Mile Post 7 West Ridge Railroad Relocation, Dam Extensions, and Stream Mitigation Project
Environmental Assessment Worksheet - Record of Decision

March 1, 2024

MILE POST 7 WEST RIDGE RAILROAD RELOCATION, DAM EXTENSIONS, AND STREAM MITIGATION PROJECT EAW
RECORD OF DECISION - ATTACHMENT A
FINDING OF FACT 13.a - COMMENT LETTER - DAYTON, CHARLES

(A) Downstream dam construction method (new raises rest on ground).

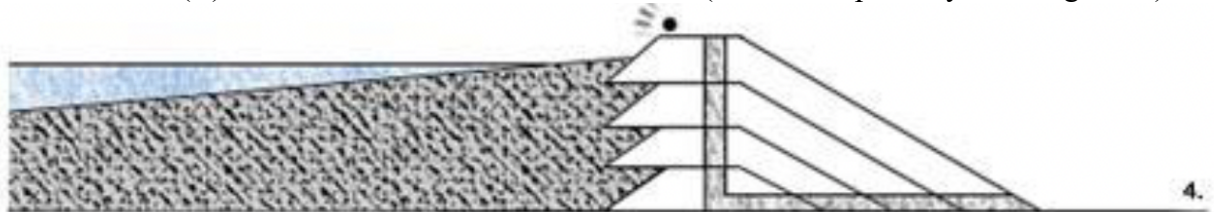
41. The following figures from Dr. Emerman’s report, *Emerman 2021* at 12-14, 23, illustrate the (A) downstream, (B) centerline, (C) upstream and (D) modified centerline/offset upstream construction methods:

43. Dr. Emerman's conclusion that upstream dams have a higher likelihood of failure than downstream dams has not been disputed by DNR.

(C) Upstream dam construction method (new raises rest on tailings)

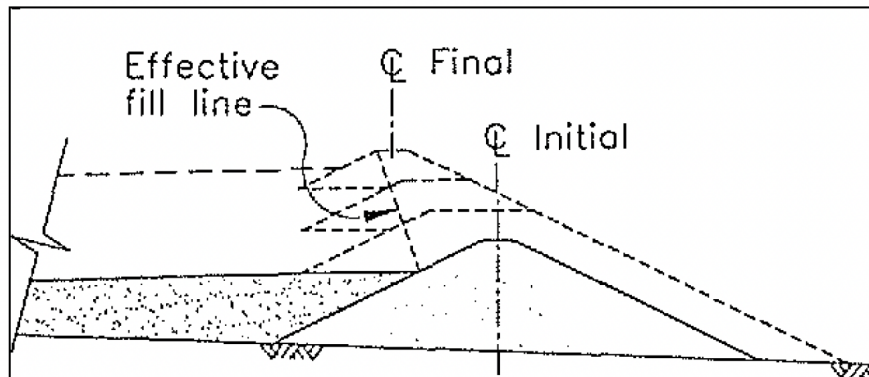
42. Dr. Emerman's report, summarized recent data on dam failure risks:

45. Dr. Emerman’s report explained that tailings dams “constructed using the upstream method are especially vulnerable to failure by either seismic liquefaction or static liquefaction because the dam is built on top of the uncompacted tailings.” *Emerman 2021* at 17. As a result, “even if the dam temporarily maintains its structural integrity while the underlying tailings liquefy, the dam could fail by either falling into or sliding over the liquefied tailings. *Id.*

Figure 3. Stability of tailings facilities. Proportion of facilities with a stability issue by raise type. Error bar lengths are binomial confidence intervals for the subsample represented by each bar, showing ± 1 standard error (approximately 68%).

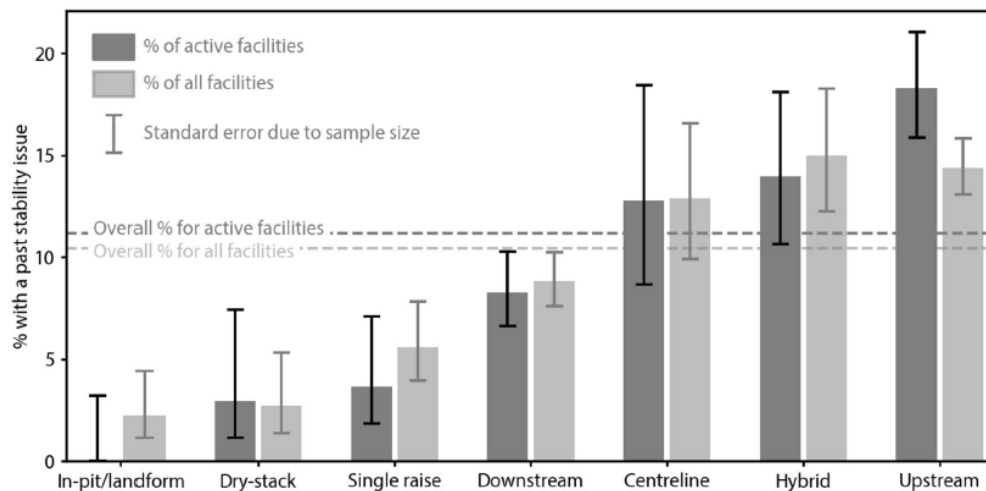
44. Peer-reviewed literature published in 2021, Franks *et al.* (2021) cited in *Emerman 2021* at 37, graphed tailings dam stability issues by type of facility, as reproduced on the next page:

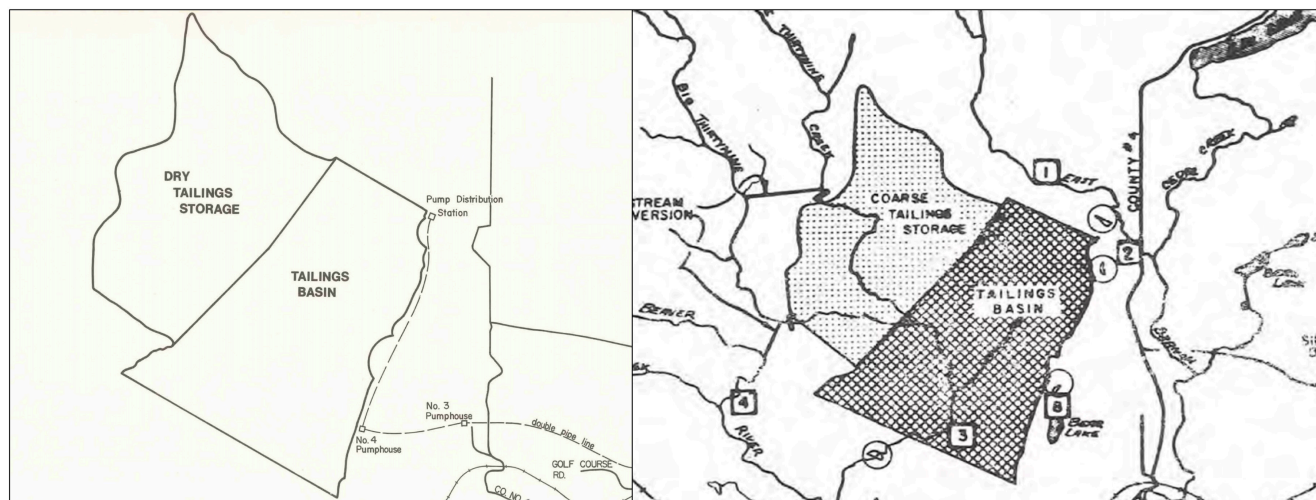
55. It is undisputed that the Mile Post 7 proposed project would extend the tailings basin and add 650 acres to the current tailings basin area, as shown in the images below from the *DNR 2021 ER Memo* at 17.

58. However, DNR has asserted that, since the 1976 Final EIS did not break down the areas assigned for fine tailings and coarse tailings, the record could be interpreted to allow ~2,950 acres allocated for a tailings basin containing 753,023,000 tons of wet slurry tailings. *DNR 2022 ROD*, ¶¶75, 83.

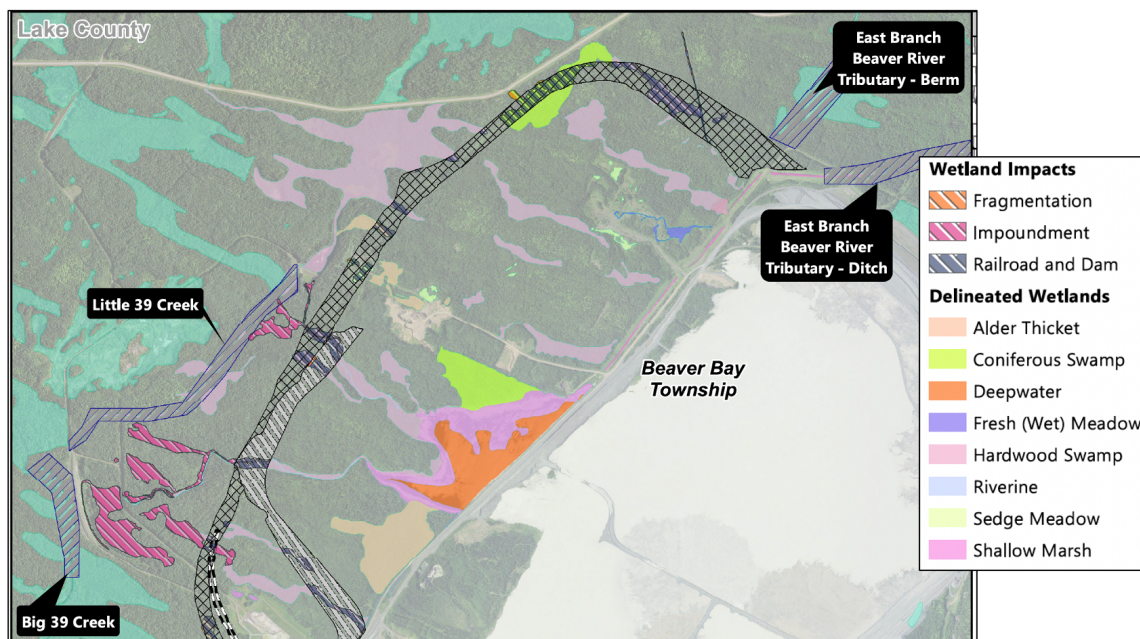
83. DNR acknowledges that the proposed new railroad would abut the full length of the Dam 2 extension and would also be constructed on a small section of the Dam 1 extension. *DNR 2022 ROD*, ¶47c.

84. None of the 1975-1977 state or federal environmental review documents evaluate a proposal to locate a railroad embankment on a portion of the Mile Post 7 tailings basin dams.
